ROLLING MEADOWS CHANNEL & FLOODPLAIN MODIFICATION

EPC STORMWATER REVIEW COMMENTS
IN ORANGE BOXES WITH BLACK TEXT

PCD-ENGINEERING REVIEW COMMENTS
IN BLUE BOXES WITH BLUE TEXT

60% DESIGN PLANS
JANUARY 2023

| OVERALL DRAINAGE PLAN - LOWER REACH | | | |

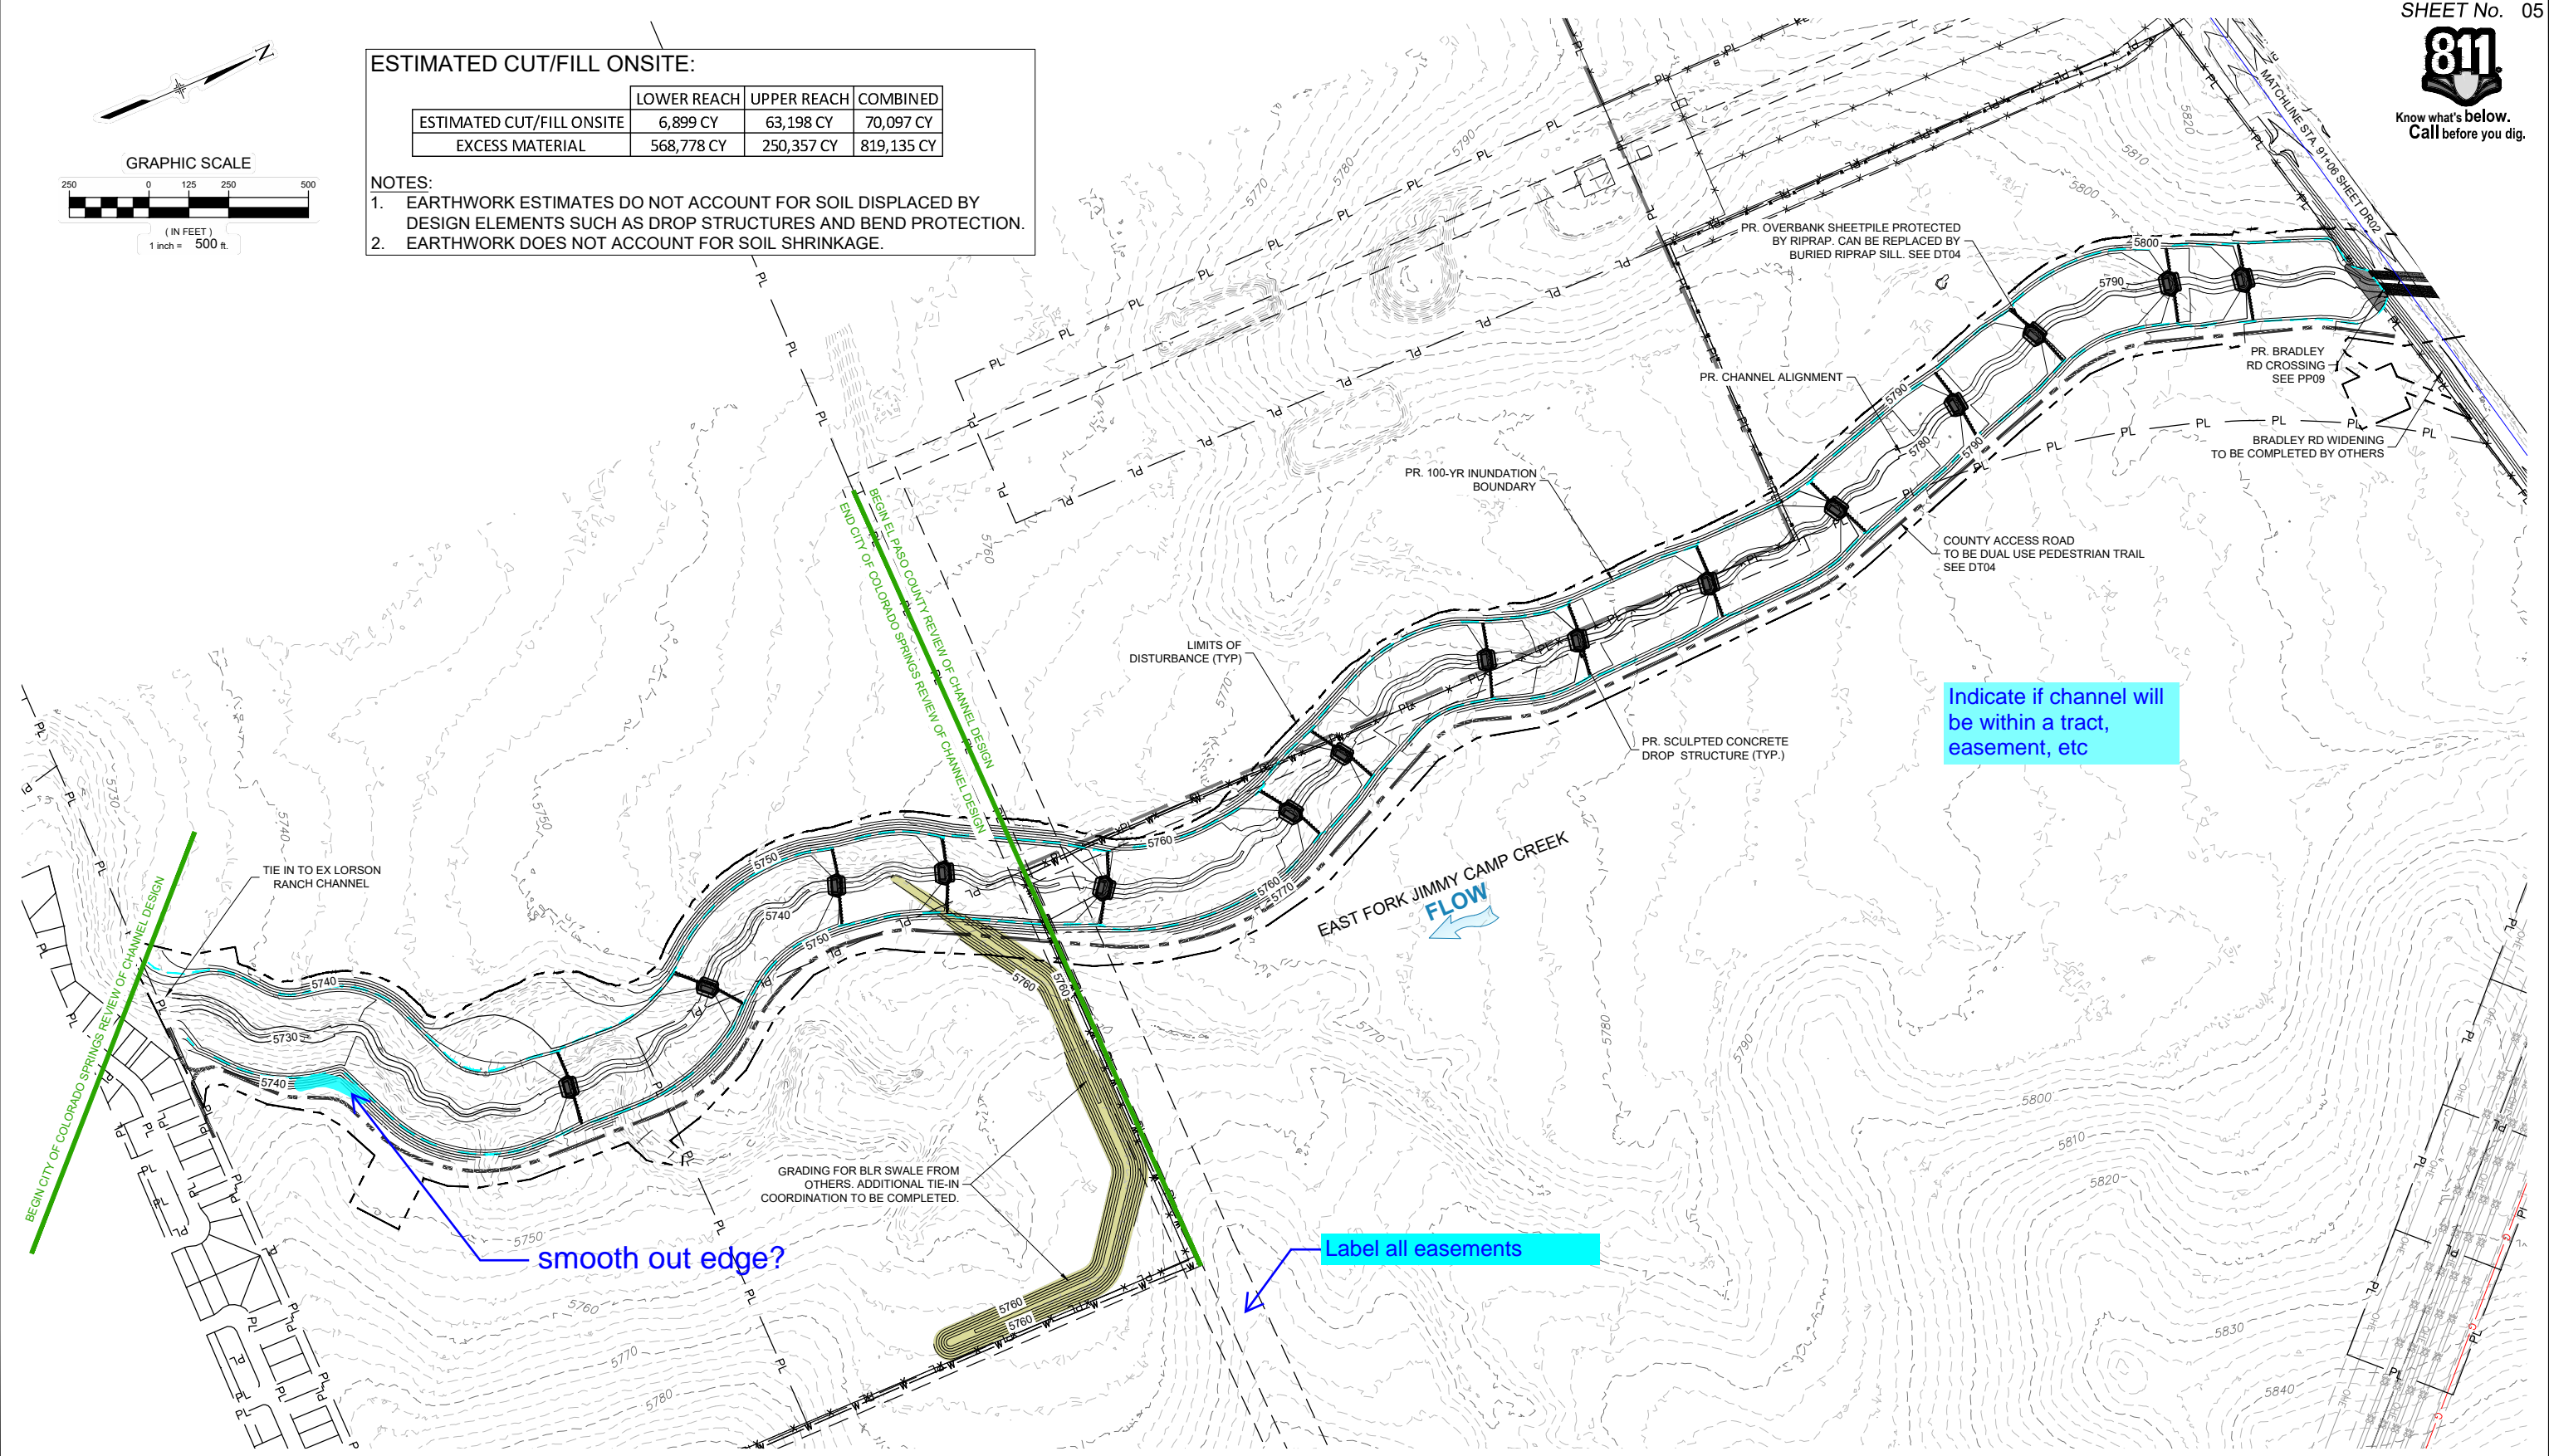
Indicate if channel will be within a tract, easement, etc

| HORIZONTAL CONTROL PLAN - LOWER REACH | | | |

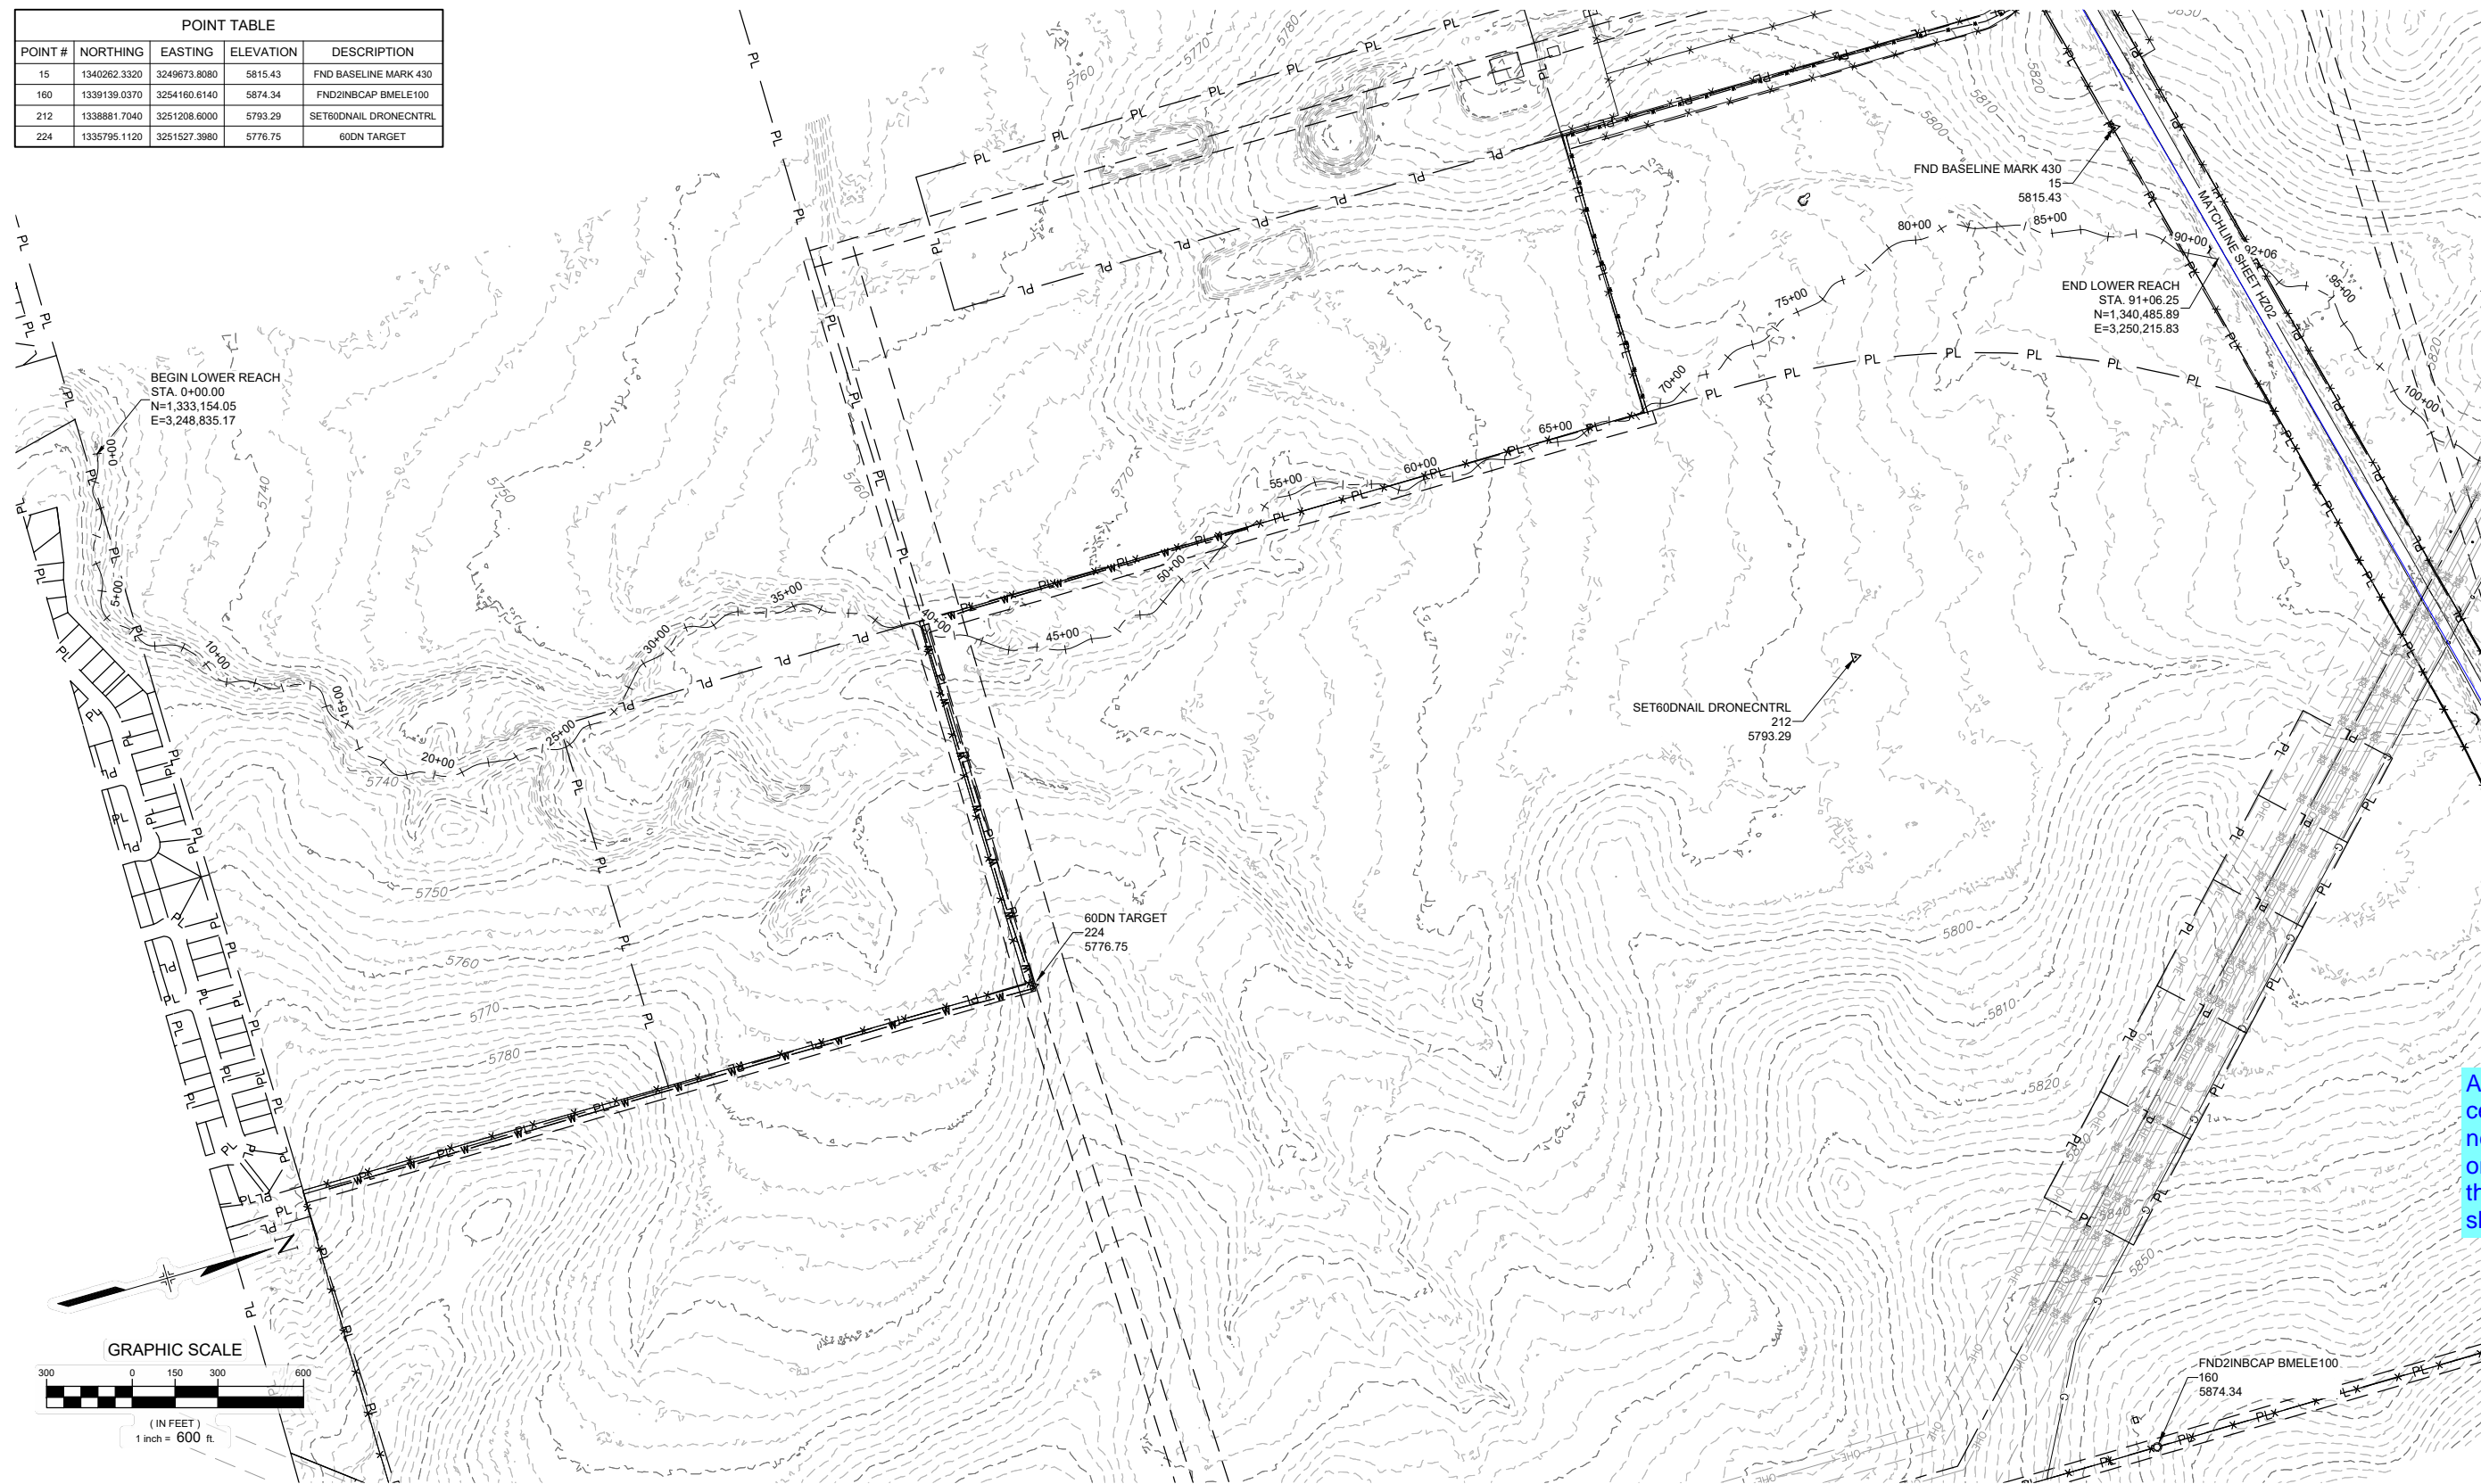
Alignment table or centerline labels will need to be added on this sheet or on the plan & profile sheets

EROSION CONTROL PLAN - LOWER REACH

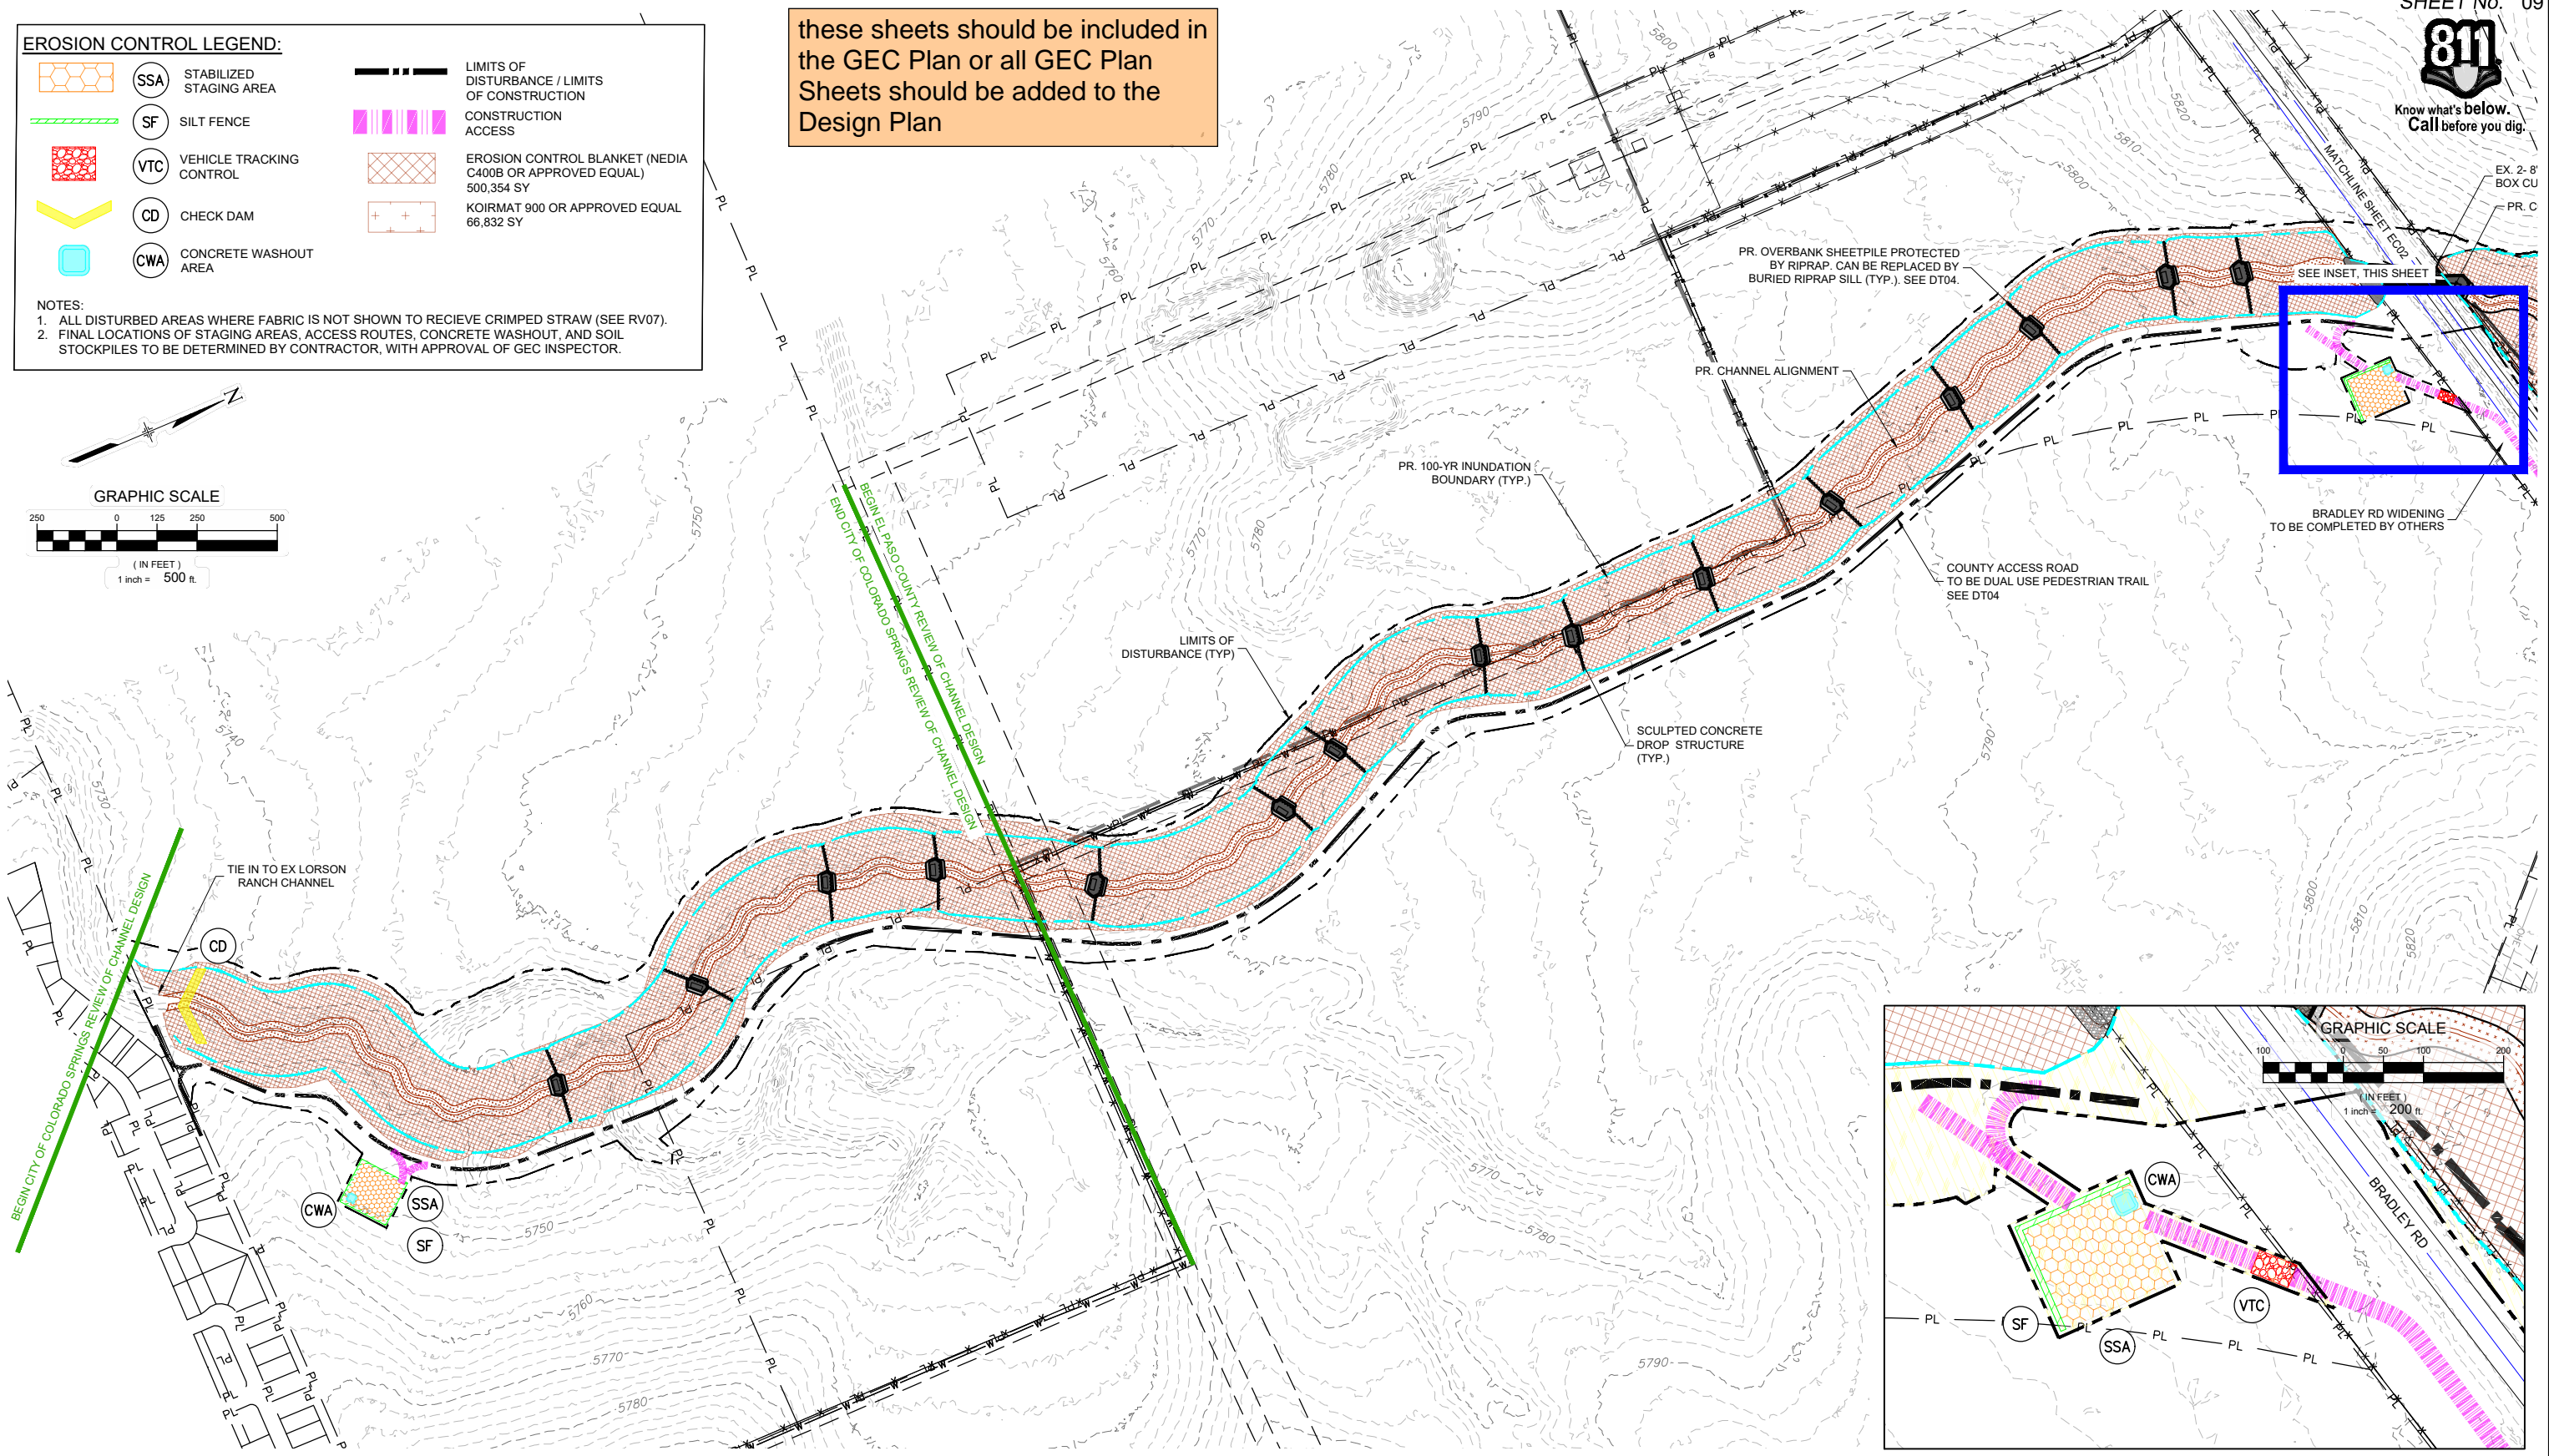
these sheets should be included in the GEC Plan or all GEC Plan Sheets should be added to the Design Plan
